**SLOVENSKI STANDARD**  
**SIST EN 1994-1-1:2005/AC:2009**  
**01-junij-2009**

**Evrokod 4: Projektiranje sovprežnih konstrukcij iz jekla in betona - 1-1. del:  
Splošna pravila in pravila za stavbe**

**EN 1994-1-1:2004/AC**

This corrigendum becomes effective on 15 April 2009 for incorporation in the three official language versions of the EN.

**19) Modification to B.2.2**

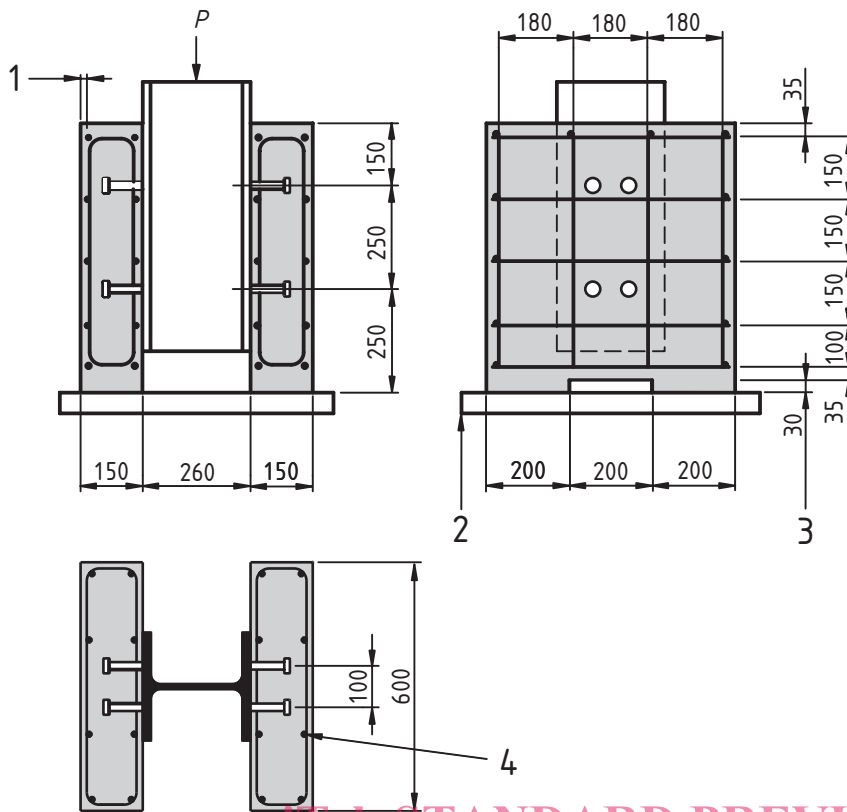
Page 111, "Figure B.1", replace the figure with the following one:

## 20) Modifications to B.3.6

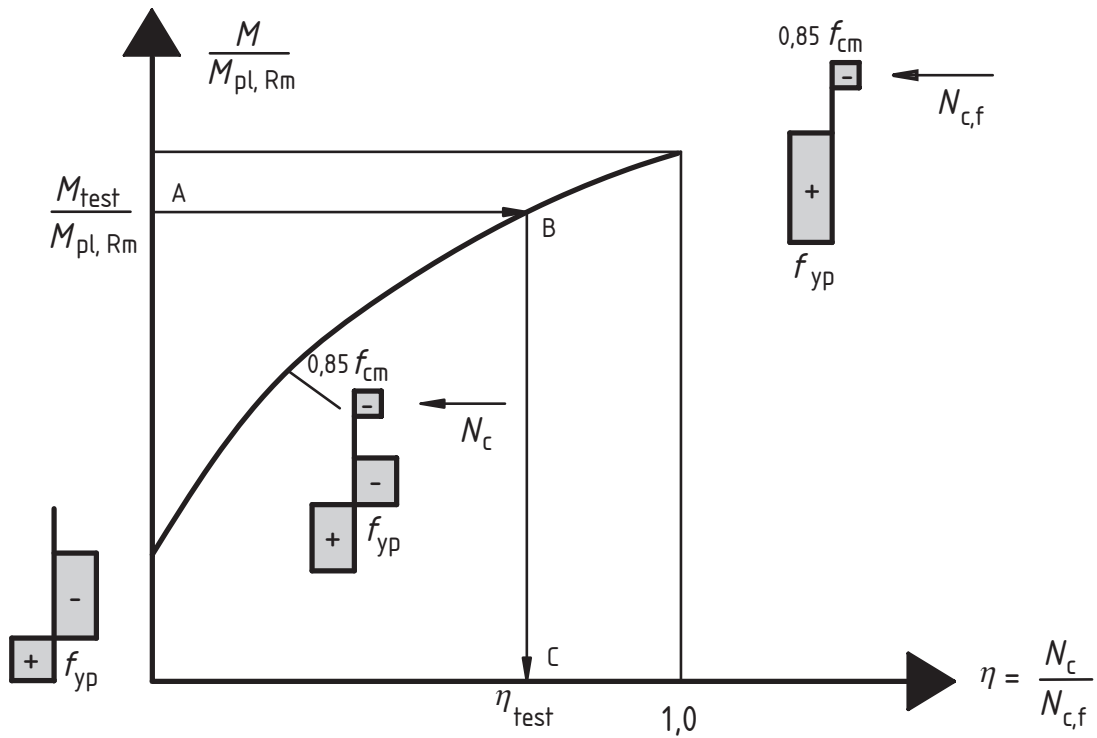
Page 117, paragraph "(2)", "Figure B.5", replace the left part of the Figure with the following one (in which " $N_{cf}$ " is replaced with: " $N_{c,f}$ ", " $M_{p,Rm}$ " with: " $M_{pl,Rm}$ ", and " $f_{cm}$ " with: " $0,85 f_{cm}$ ");
